SERVICE BULLETIN AMATEUR RADIO

SUBJECT	DATE	
TS-950SD RX DIGITAL NOISE		01/17/90

FIGURE 2 PAGE 2 OF 2

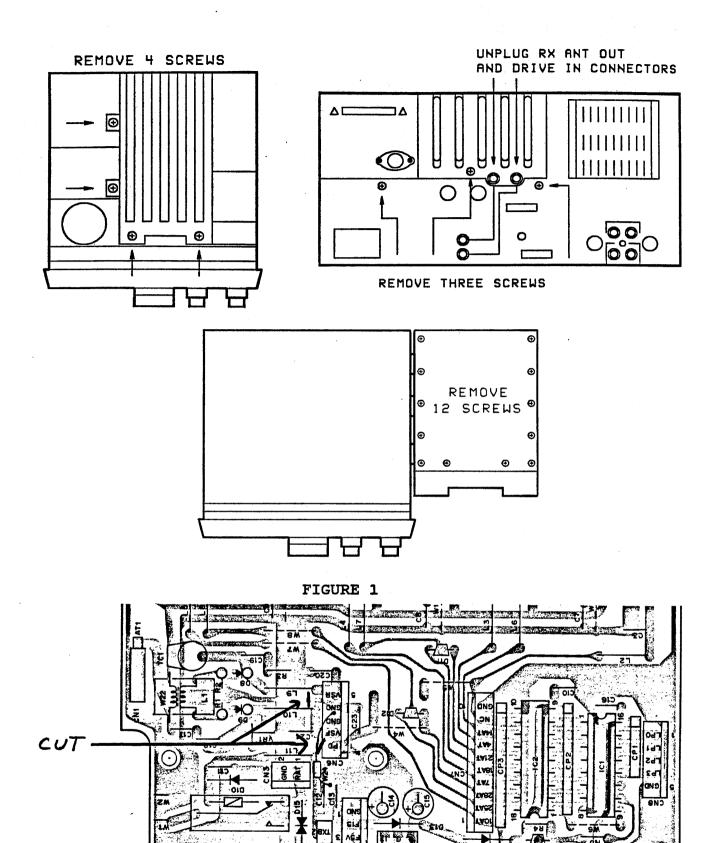
Some early TS-950SD transceivers may exhibit a low Signal to Noise ratio on ten and fifteen meters. In addition, rotating the encoder may allow the user to hear a crackling noise in his headphones. The following modification will correct this condition.

- Disconnect the power cord and antenna.
- 2. Remove the top and bottom covers (18 screws).
- Open the subchassis as shown in figure 1 (remove 4 top screws, remove 3 back panel screws, unplug the RX ANT OUT and DRIVE IN connectors).
- 4. Remove the cover from the subchassis (12 screws). FIGURE 1.
- 5. Remove the 9 screws from the Filter board.
- 6. Desolder the antenna connector wires at the antenna connector. Do not damage the surge absorber.
- 7. Rotate the Filter unit to expose the foil side of the board. Disconnect coax cables as necessary to rotate the board and remove the mesh plate as the board is rotated.
- 8. Cut the two ground foils as shown in figure 2.
- 9. Assemble the transceiver by reversing steps 1 7. Remember to install the mesh plate, resolder the antenna connector, and plug in the two connectors on the back panel.
